United States Patent and Trademark Office

DETAILED ACTION

THIS FINAL ACTION IS RESPONSIVE TO THE AMENDMENT FILED 4/2/2007.

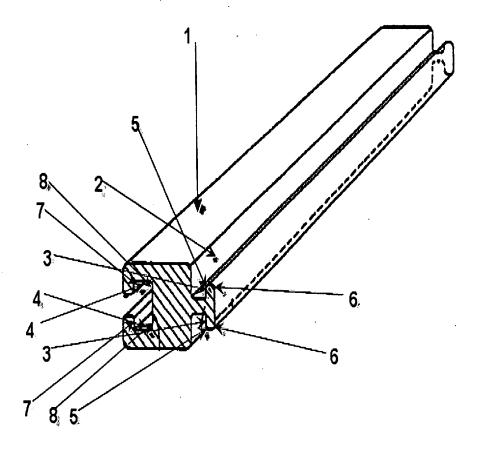
As for Claim 1, SHIRAI discloses of a bendable bottom member of a bed (see figure on the next page) comprising:

a plurality of side-by-side bars (1) bendably connected with each other allowing the whole extent of the connected bars to be shortened, extended, and curved (Fig. 2), said bars (1) being disposed generally perpendicular to the longitudinal axis of the bed, one of every adjacent two of the bars (1) being provided on one face (2) of the bar (1) with a plurality of longitudinal connecting protrusions (3) extending generally parallel to the longitudinal axis of the bed, while a plurality of recesses (4) for accepting the respective connective protrusions (3) are formed in a corresponding face of an adjacent bar (1), said recesses (4) having an approximate rectangular cross-section taken in a direction perpendicular to the longitudinal axis of the bed, said recesses (4) having right and left lateral walls and top (7) and bottom (8) walls are formed in adjacent bars (1) for accepting protrusions (3) extending from an adjacent bar (1), said protrusions (3) having an approximate rectangular cross-section taken in a direction perpendicular to the longitudinal axis of the bed, and an elongated generally rectangular cross-section tapered at its tip on a bottom face thereof taken in a direction parallel to the longitudinal axis of the bed, said protrusions (3) having faces corresponding in configuration to the walls of said recesses (4) into which the protrusions (3) engage, said recesses accommodating the insertion in a direction parallel to the longitudinal axis of the bed of protrusions therein in sliding engagement therewith in a direction parallel to the longitudinal axis of the bed so that top (7) and bottom (8) walls of

each of the recesses (4) contact a top (4) and bottom (6) face of a corresponding protrusion (3) inserted therein (Fig. 7A), said protrusions (3) having at tips and bases thereof first and second beveled portions, said firsts beveled portion being formed on a bottom (6) face of each protrusion (3) at its tip and said second beveled portion being formed on a top face (5) of each protrusion (3) at its base, said first and second beveled portions forming clearances between the protrusions (3) and corresponding faces of the recesses (4) to allow the connecting bars (1) to be bent a preset distance in one direction only (Fig. 7A), so that adjacent bars (1) can be adjusted in their intervals (each distance between bars can be different due to the diameter of the recess, 4, and also from col. 3, beginning with line 38, "...the bottom structure contain the bottom strips can be bent and also adjusted in length in the longitudinal direction of the bed") and can be rotated in one direction up to a predetermined angle, and disengagement preventing (ends of 9) means comprising hooks formed at a tip of some of the connecting protrusions (3), and corresponding accepting recesses (4) having steps therein adapted to engage the hooks, so that the hooks and steps are engaged with each other when the respective adjacent bars (1) are kept furthest away from each other (Fig. 7A), whereby said adjacent bars (1) being adjustable in gaps between adjacent bars (1) (col. 3, beginning with line 38, "...the bottom structure contain the bottom strips can be bent and also adjusted in length in the longitudinal direction of the bed"), said bars (1) being connected with each other in such a manner that they can be curved as a whole up to a limited predetermined angle in one direction only (Figs. 2, 7A).
